May 13, 2016

SUBJECT: PIER 4 PHASE 2 RECONFIGURATION
PROJECT NO. 091251
CONTRACT NO. 070136

ADDENDUM NUMBER SIX

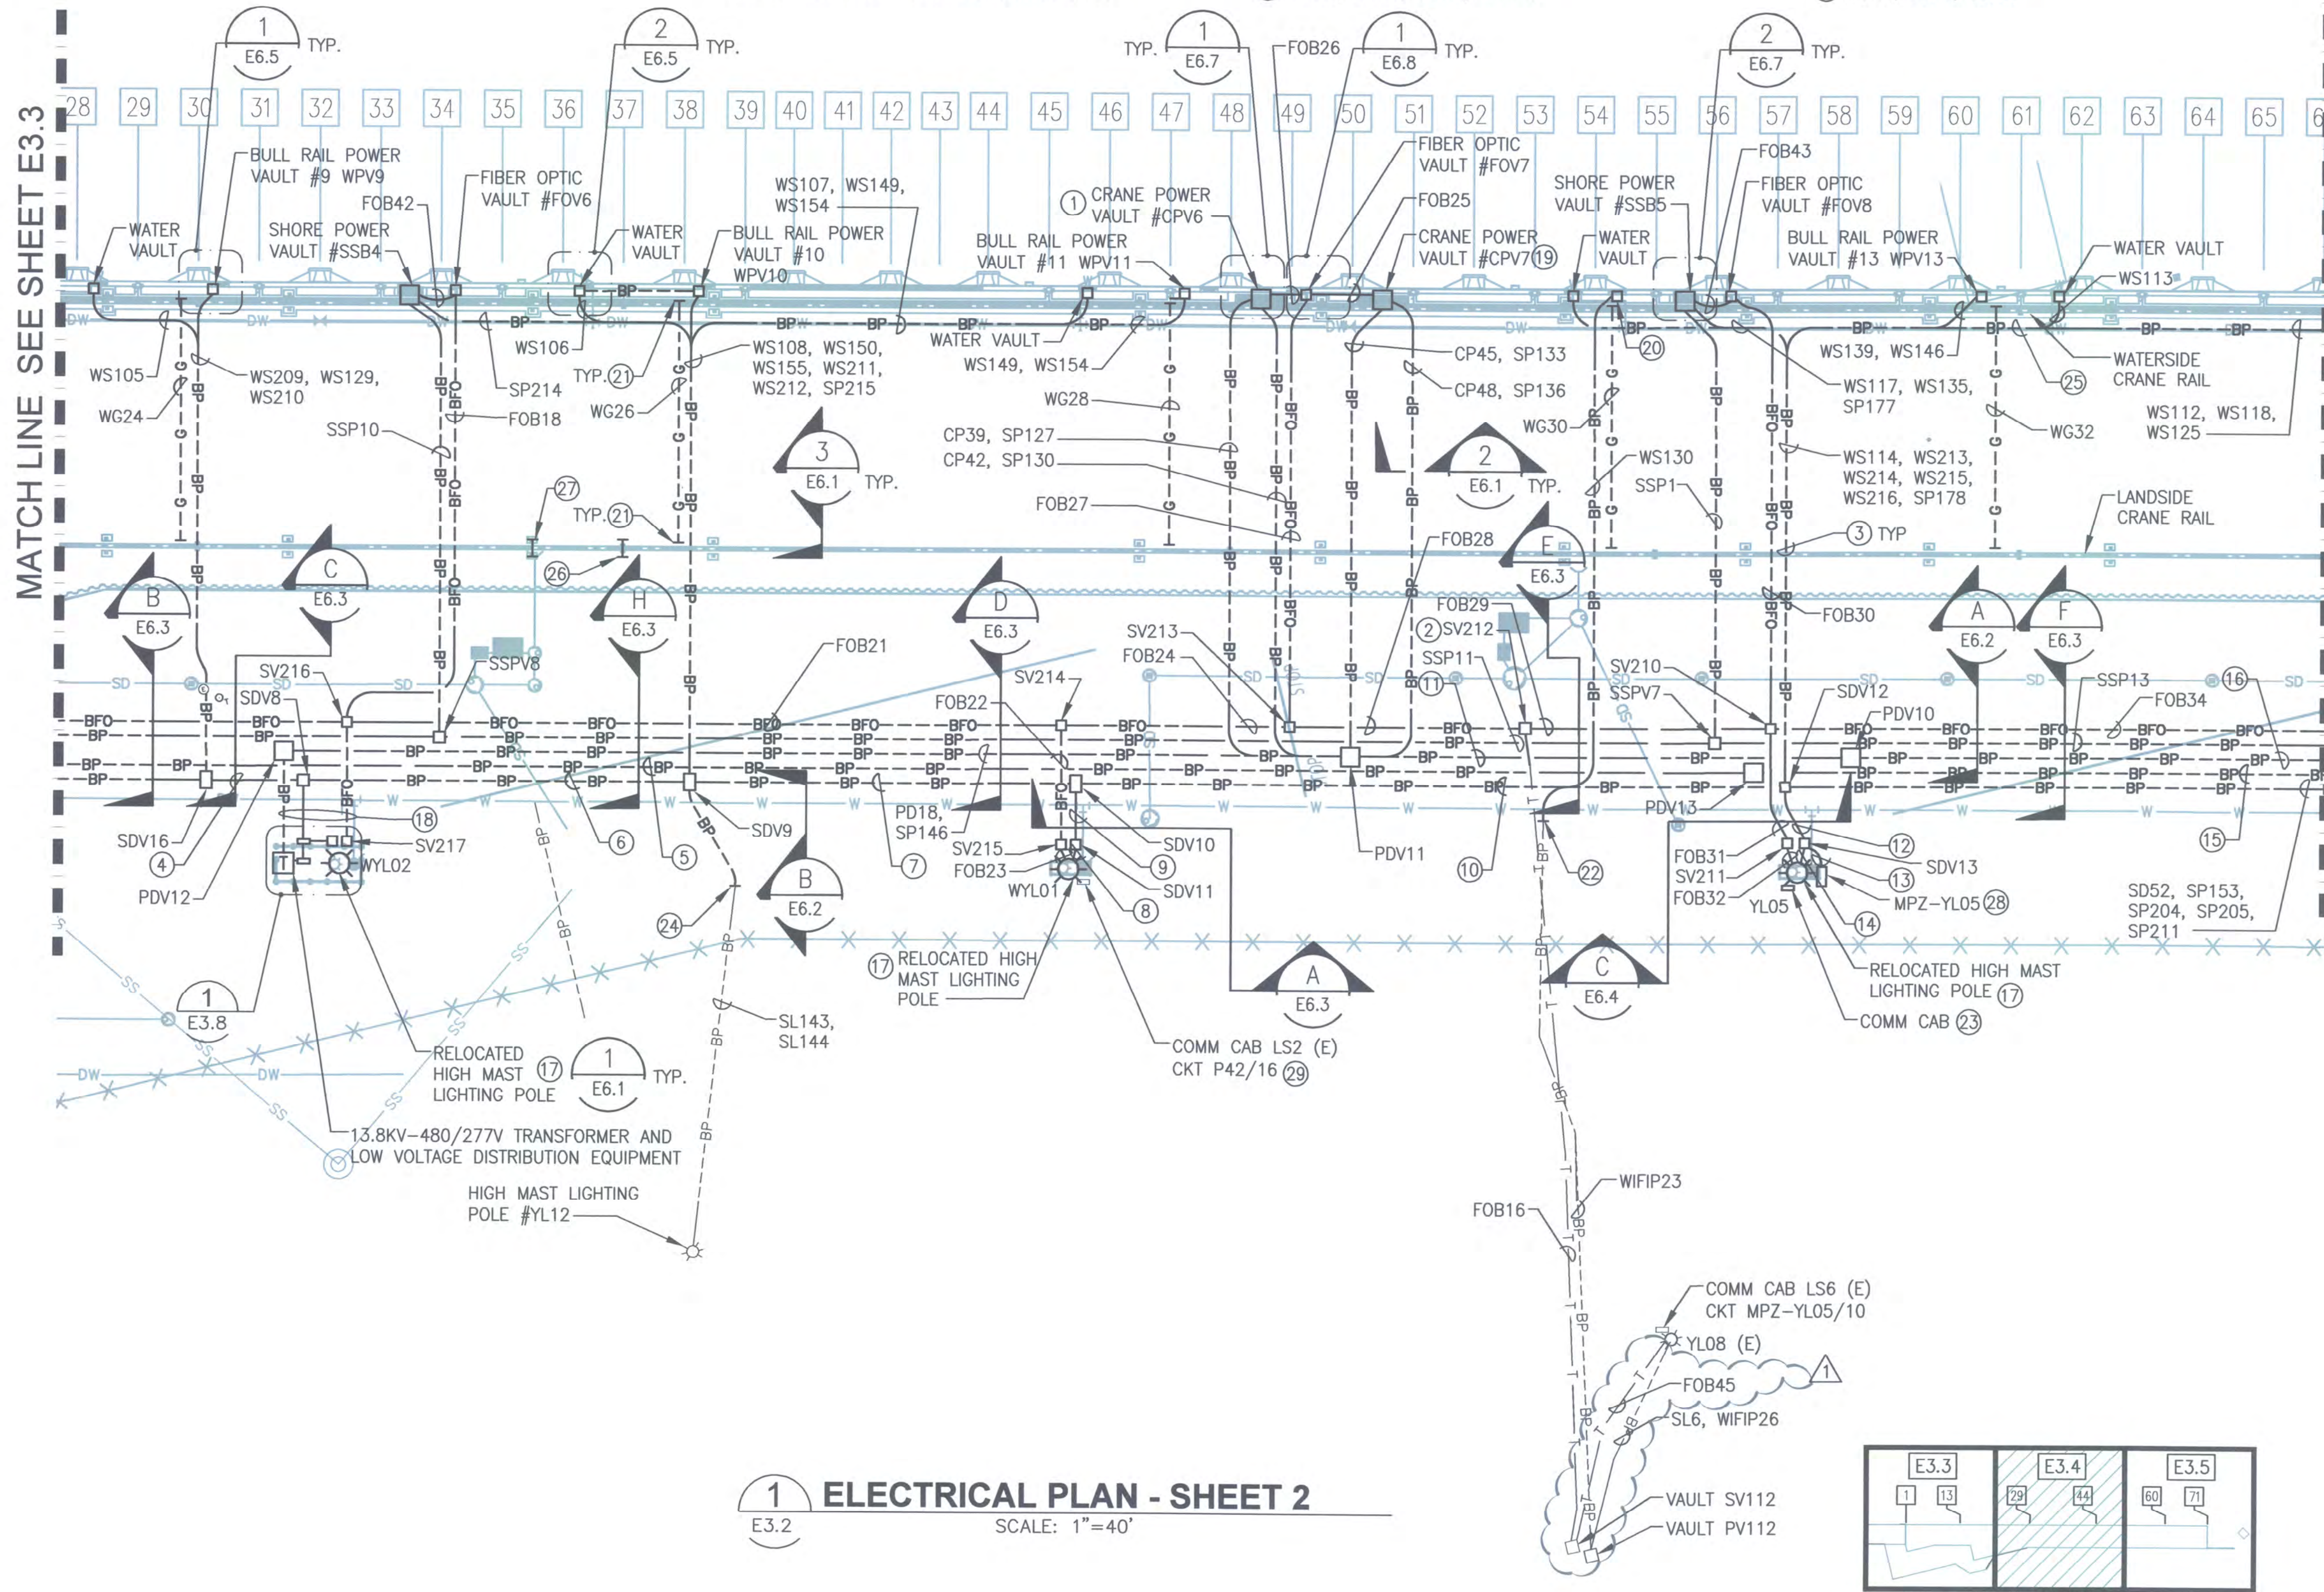
1. **ADD** callout for switchboard pad detail as denoted. (See Attachment A to this Addendum No. 6)

**ENLARGED ELECTRICAL PLAN
YARD ELEC DISTRIBUTION**
1
E3.4
1/4" = 1'-0"

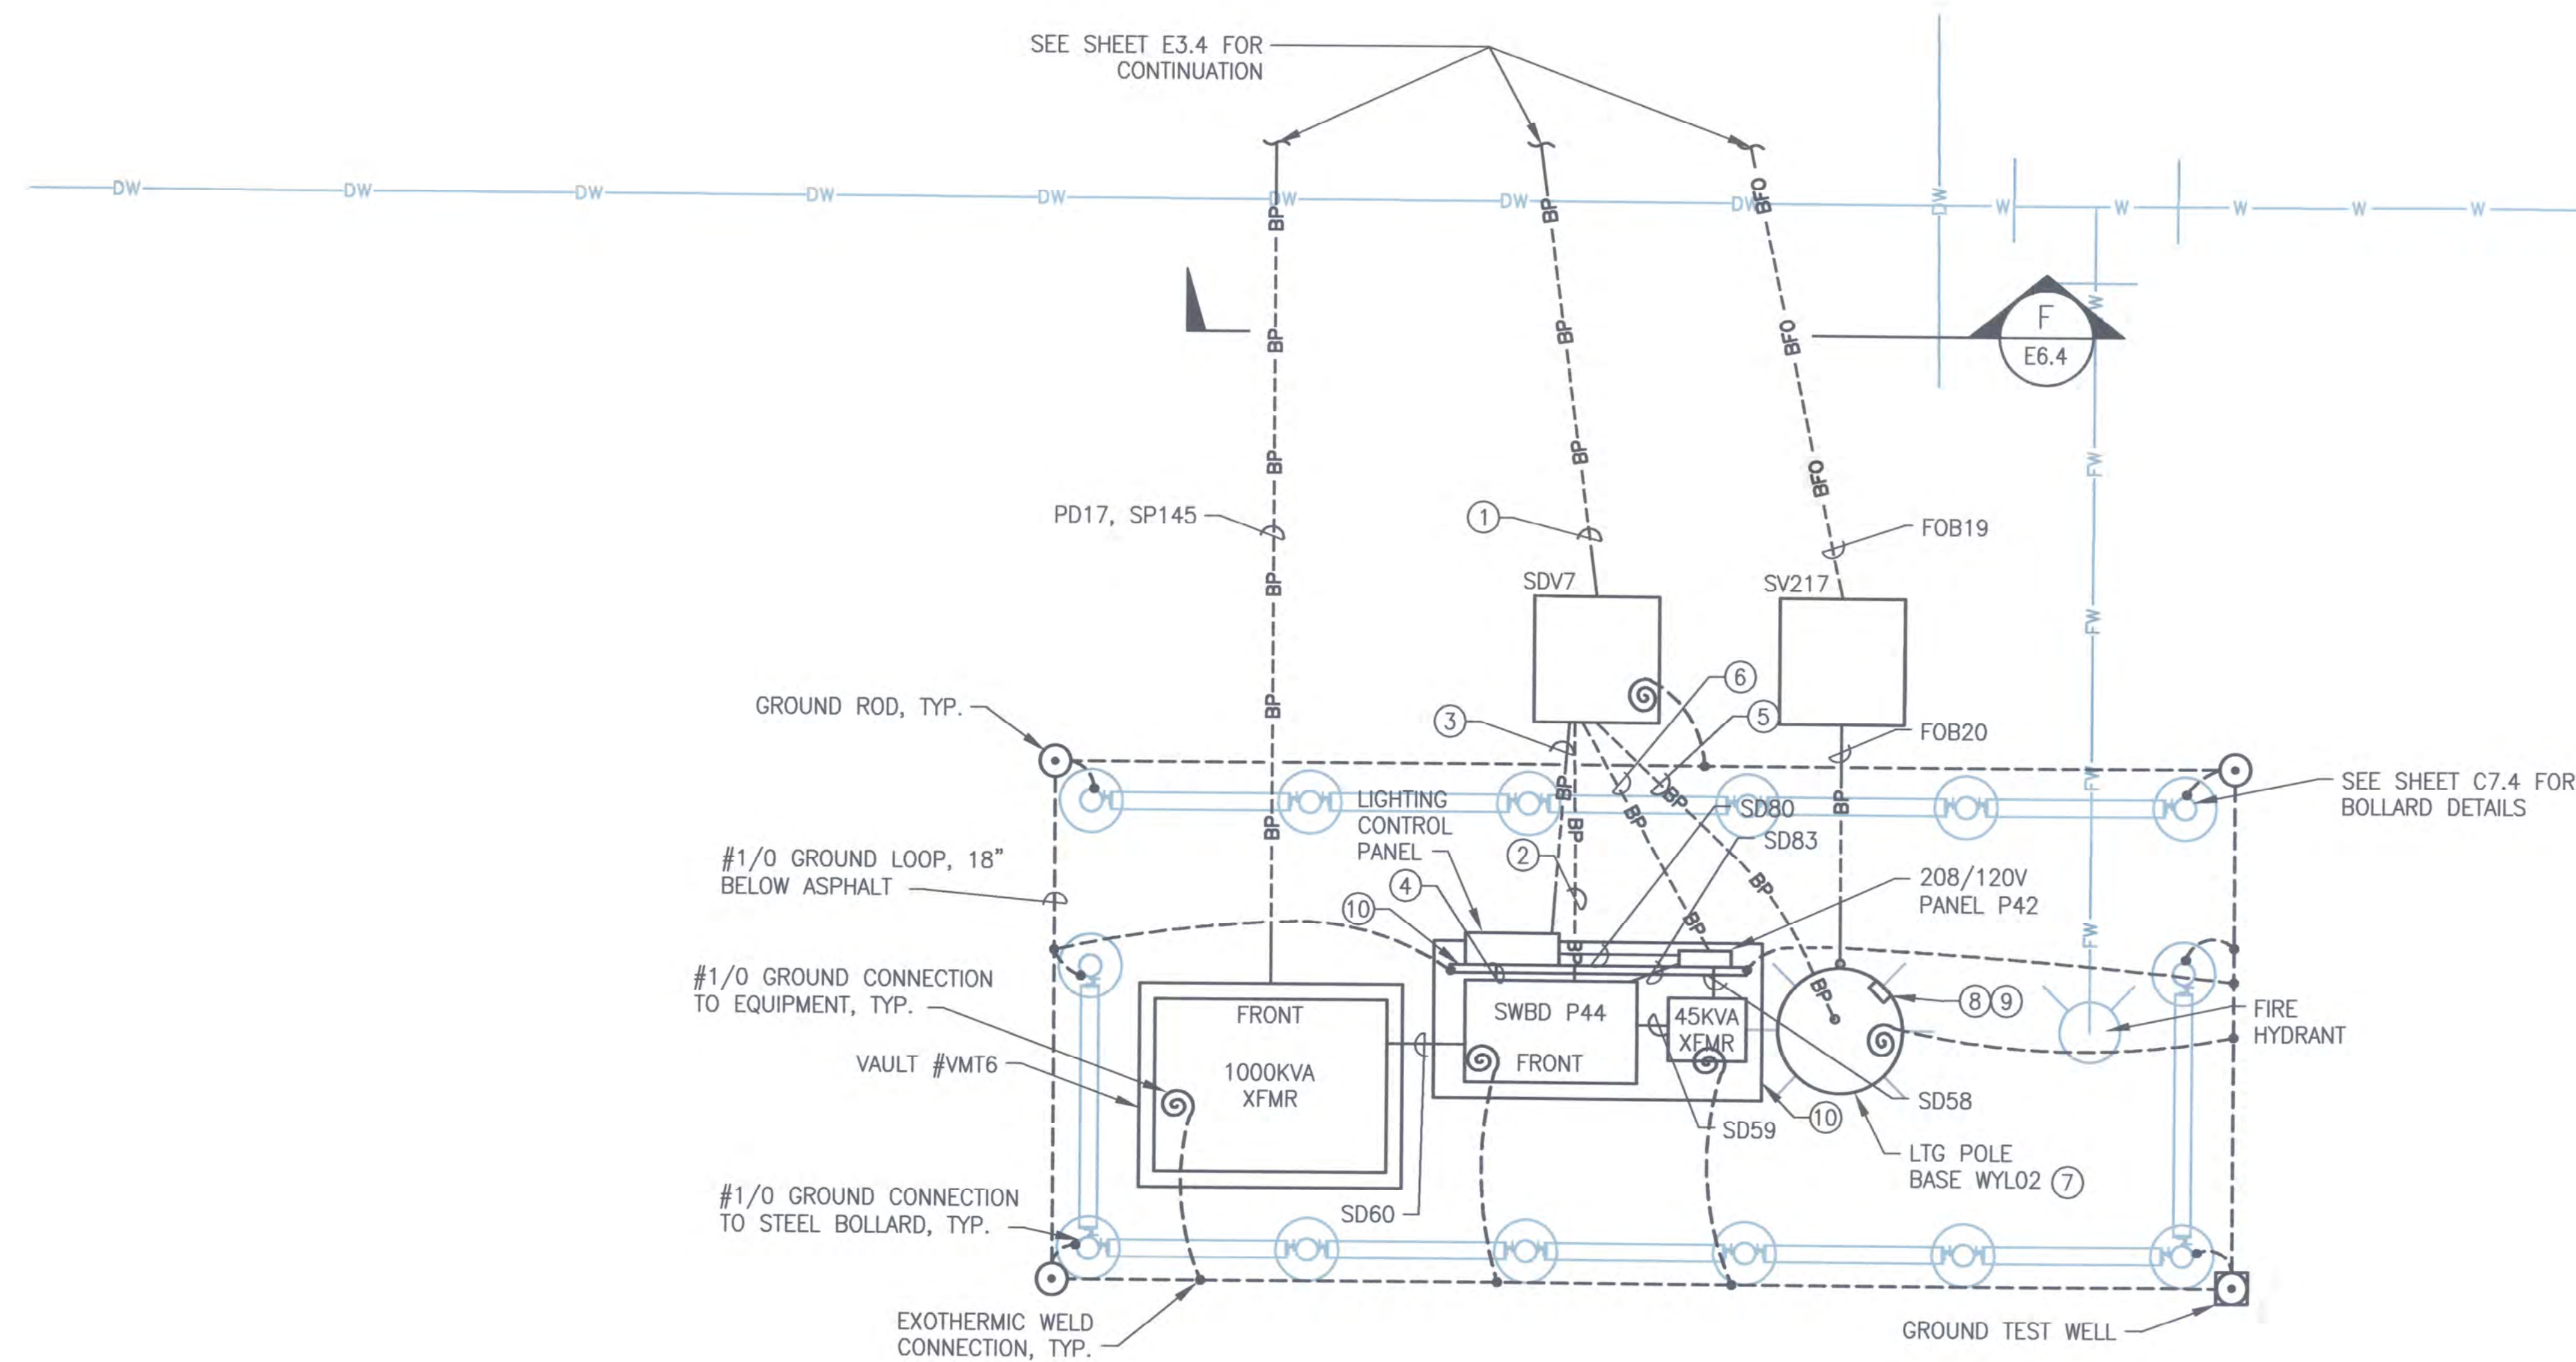
1. **REVISE** Key Note #10 as denoted. (See Attachment D to this Addendum No. 6)

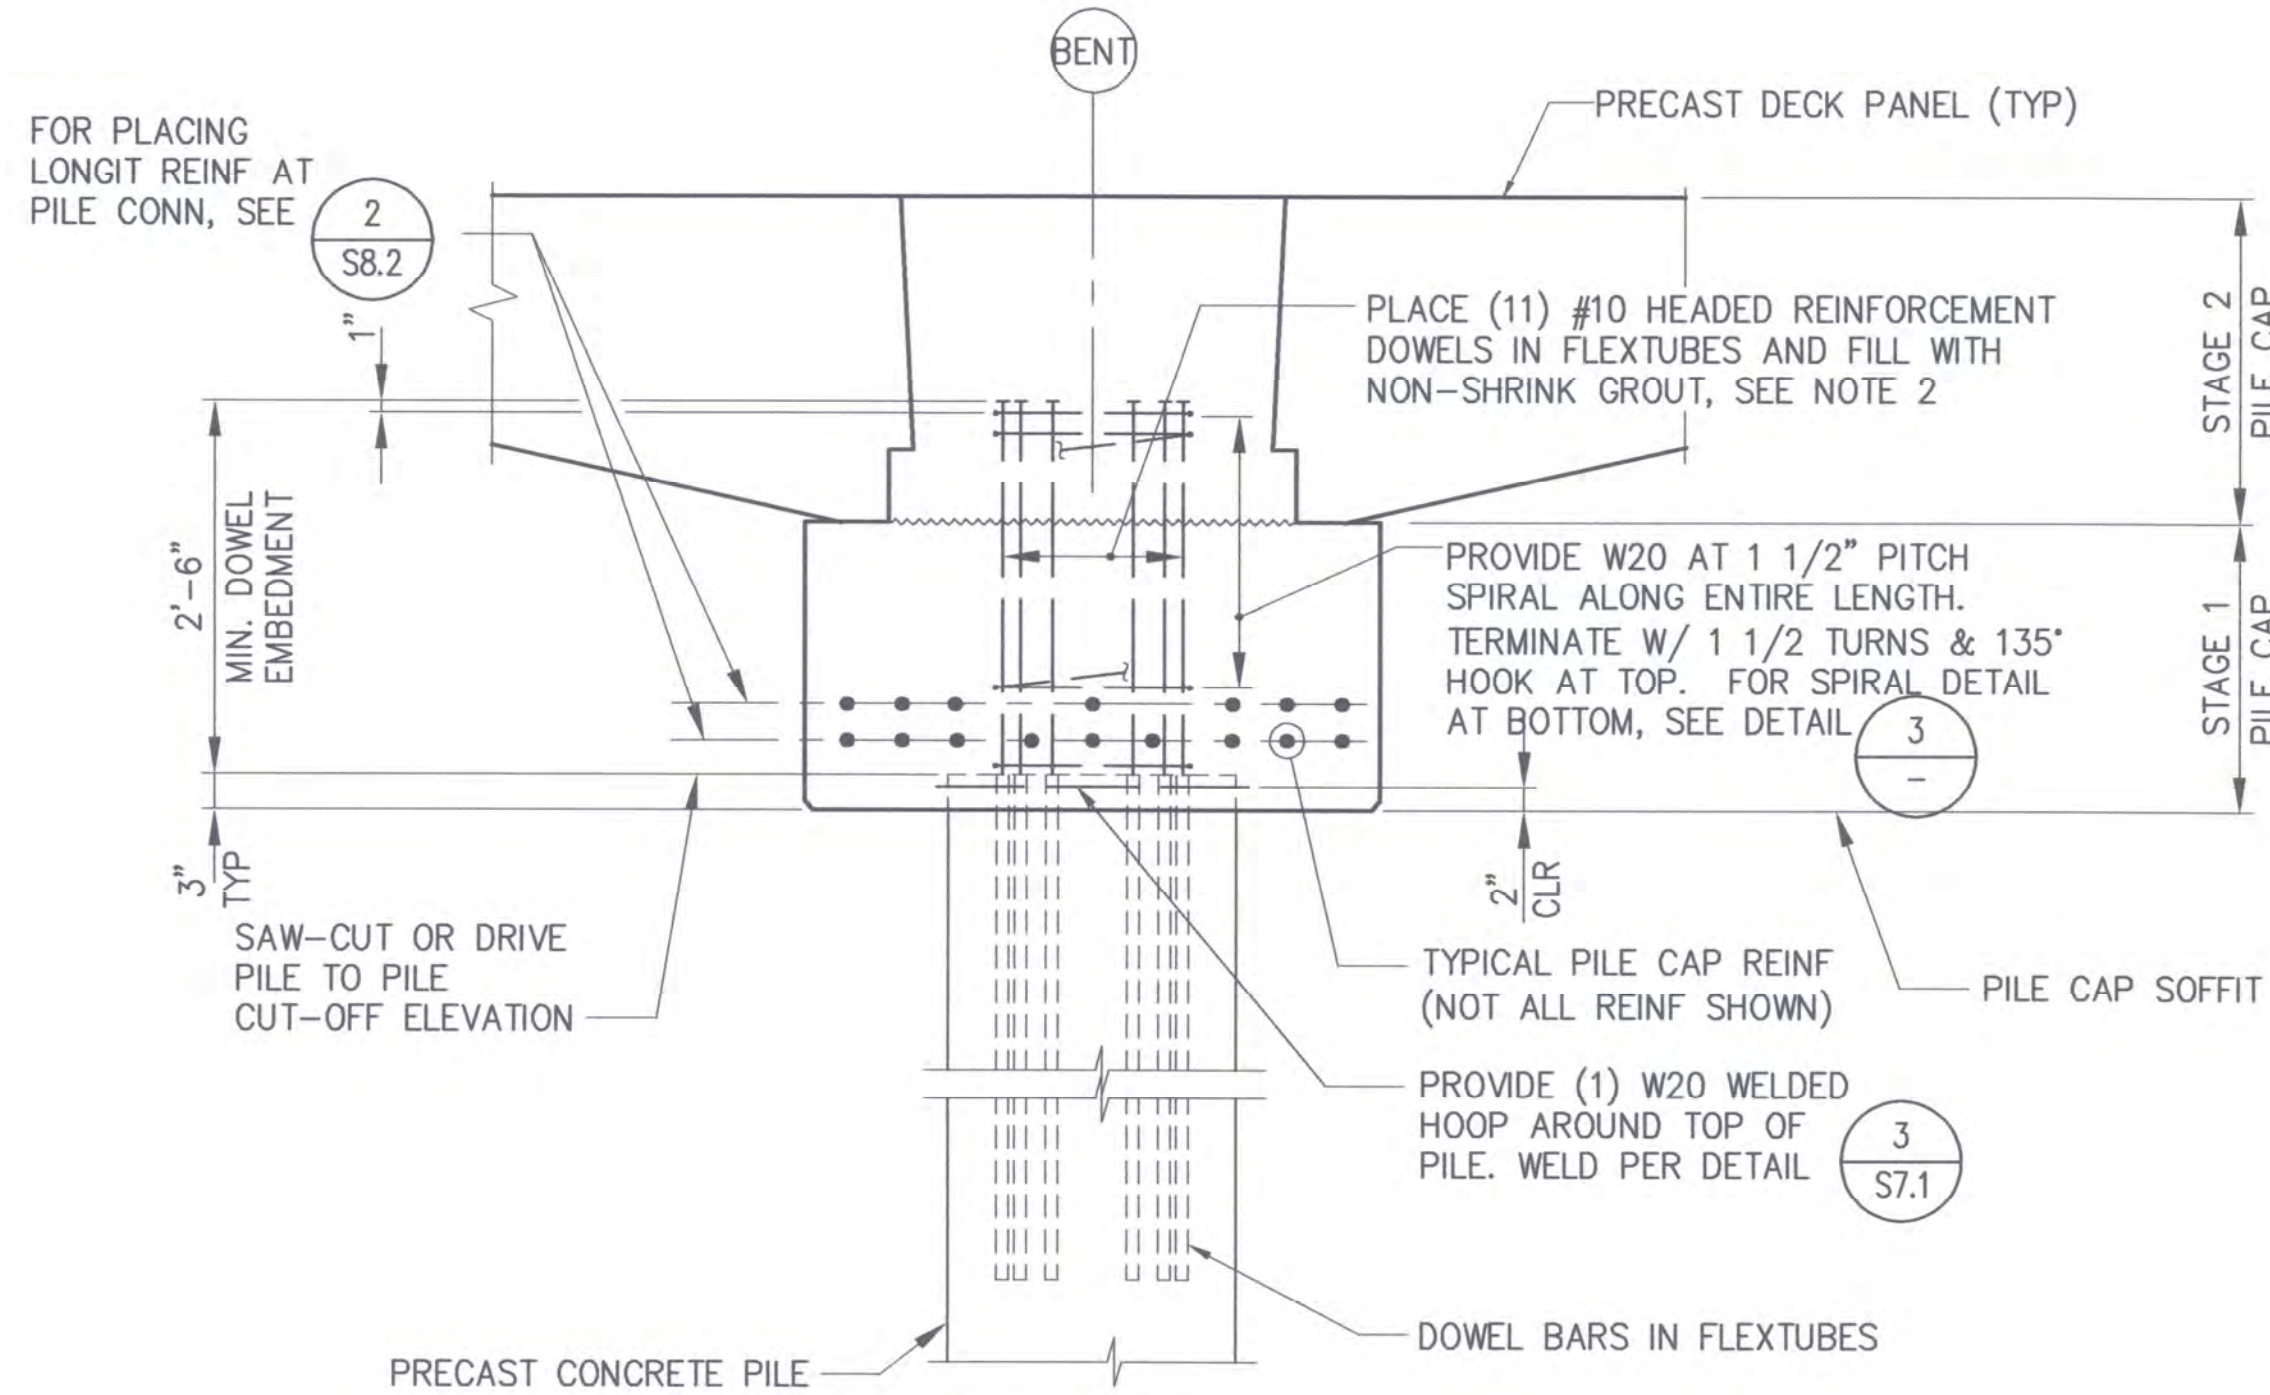
1. **ADD** conductors per key note #19 to conduit number WIFIC9 as denoted. (See Attachment G to this Addendum No. 6)

(19) EXISTING (2) 50-PR COPPER CABLES, (2) 12-FIBER MM FO CABLE, (1) 12-FIBER SM CABLE, (1) 6-FIBER SM FO CABLE. PROVIDE (1) 144-FIBER SM FO CABLE. PROVIDE (2) 3-CELL MAXCELL INNERDUCTS IN EACH EMPTY CONDUIT.
